CERTIFICATE OF APPROPRIATENESS

Applicant: Robert Covington, Covington Custom Builder, owner

Property: 1911 A Crockett St, Lot 4, Block 1, Barclay Estates Subdivision. The property is a vacant interior lot, subdivided into two lots, Lot A measuring 2,604 square feet (42' x 62') and the Lot B measuring 1,596 square feet (42' x 38').

Proposal: New Construction – Residence/Garage *Deferral*

NORTH ELEVATION – FRONT FACING CROCKETT STREET

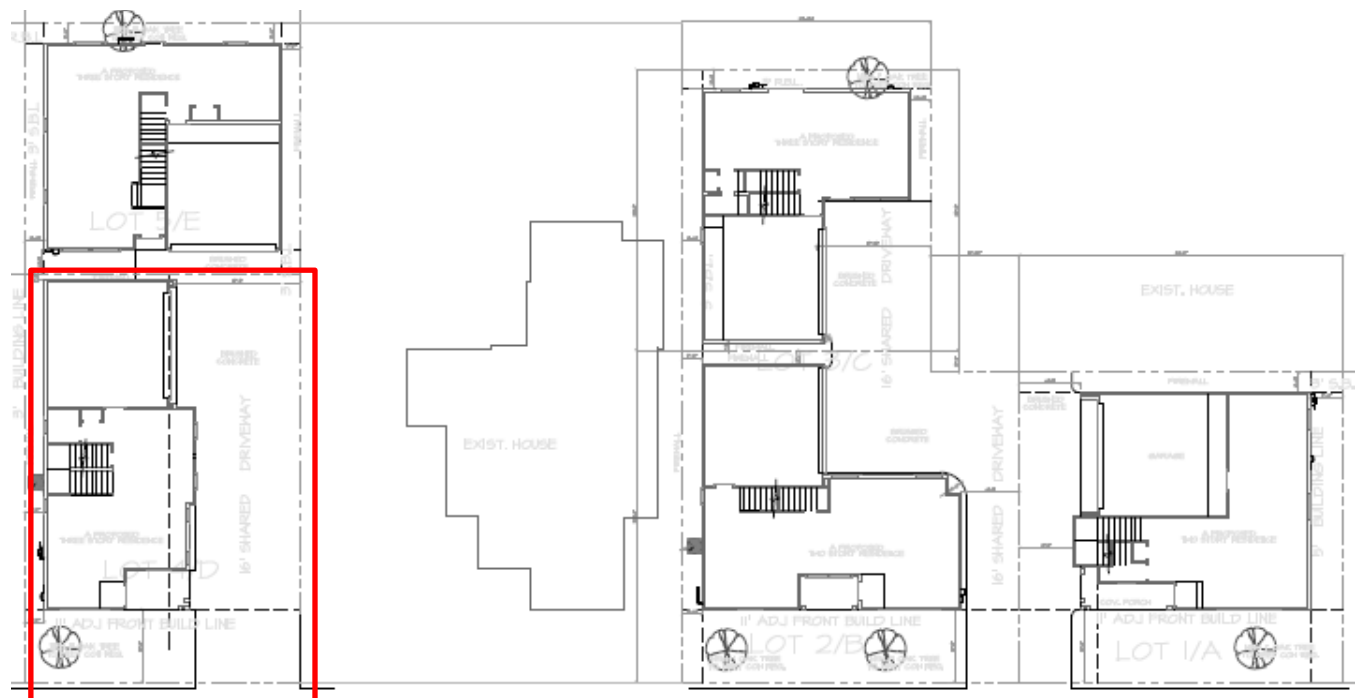
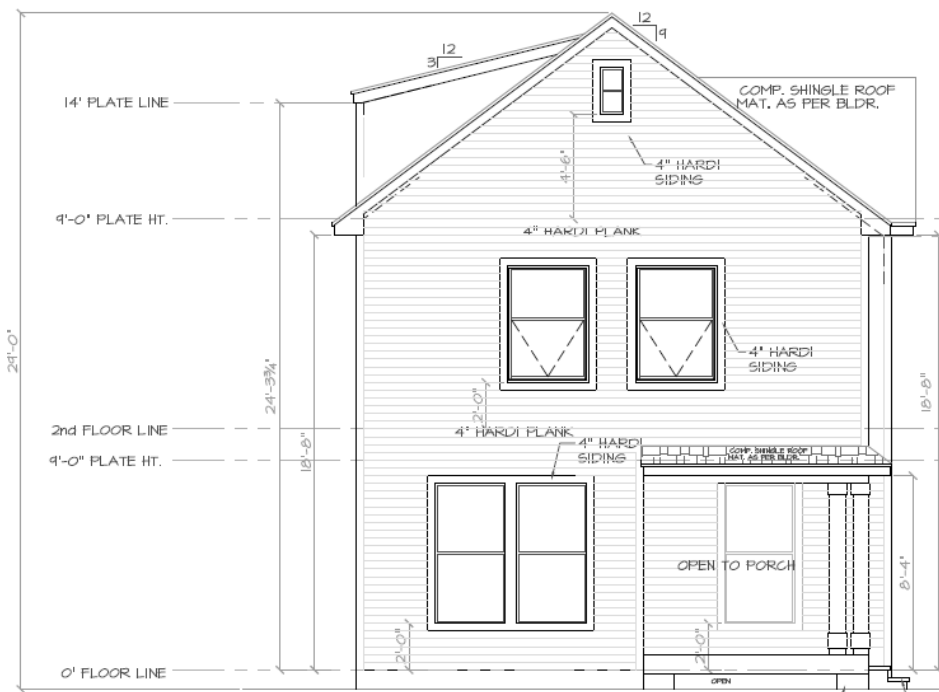
- 2.2. In addition, several of the proposed structures (1911A, 1911B, 1913B) stretch the definition of what can be considered a two-story structure. By incorporating dormers (in order to capture additional living space in an area which in a traditional historical structure would be an unfinished attic), they create additional massing, worsening the contrast with and dwarfing of 1907 Crockett and the other contributing structures. These proposed new buildings are really two-and-a-half-story structures.

- 3.1. 8" hardie plank has been specified throughout. This material is cheap-looking and not in keeping with the historic structures in the District. 4" plank should be used instead. Additionally, the texture of the planks to be used is not noted; flat-texture planks should be used.
- 3.2. Glass block has been specified in all of the designs. This material does not seem appropriate for a historic district.
- 3.3. Many of the windows in the designs are large, single-pane fixed windows. This type of window does not seem appropriate to this historic district. 1-over-1 and 2-over-2 double-hung windows are the norm in this district.

SITE PLAN

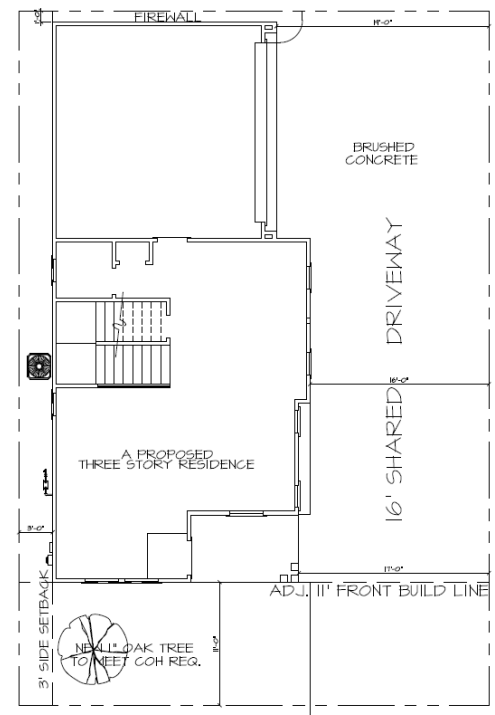
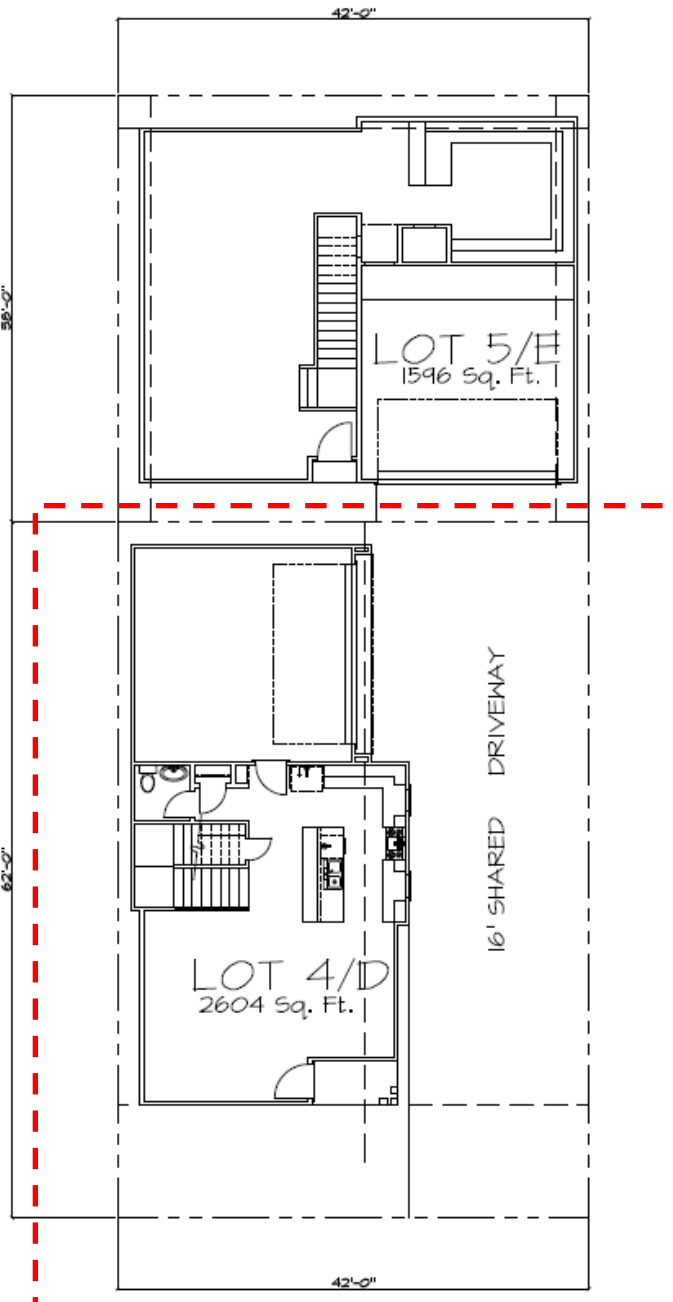
1. Site plans

- 1.1. A site plan is required for a COA application. Each of these applications includes a drawing labeled "Site Plan". However, these purported site plans do not indicate the orientation of the proposed buildings to the surrounding streets or to each other. In addition, the elevations are listed as "left", "right", etc. instead of the usual "north", "south" etc. All this is contrary to industry standards, and makes the site plans are very difficult to decipher. This needs to be addressed in order to make the proposed plans more readily understandable.

- 1.2. Given the close proximity and interrelationships of the proposed buildings with one another, a site plan should be provided that covers all the buildings in the project so that what is being proposed can be understood.

- 1.3. With respect to the applications for 1911A and 1911B Crockett: according to the records available online, the 5,000 square foot lot in question is platted into 3 lots, so one might have expected to see applications for 1911A, 1911B and 1911C. However, no COA application for 1911C appears to have been made. Are we to understand that the 5,000 square foot lot is being replatted into two instead of three, i.e., that 1911A and 1911B are going to take up the full 5,000 square feet? This is another point that the site plan should have made clear, but doesn't.

- 1.4. The historic/contributing structure at 1907 Crockett is known to encroach on its neighbor to the west (1913 Crockett). This encroachment is not shown on the site plan. This omission is significant, since it affects the actual distance that will separate the new structure at 1913 from the existing one at 1907.

- 1.5. A 10' setback from the street is noted. This is out of character for the District, where setbacks of 15 feet or more are prevalent on contributing structures. Is this permissible?
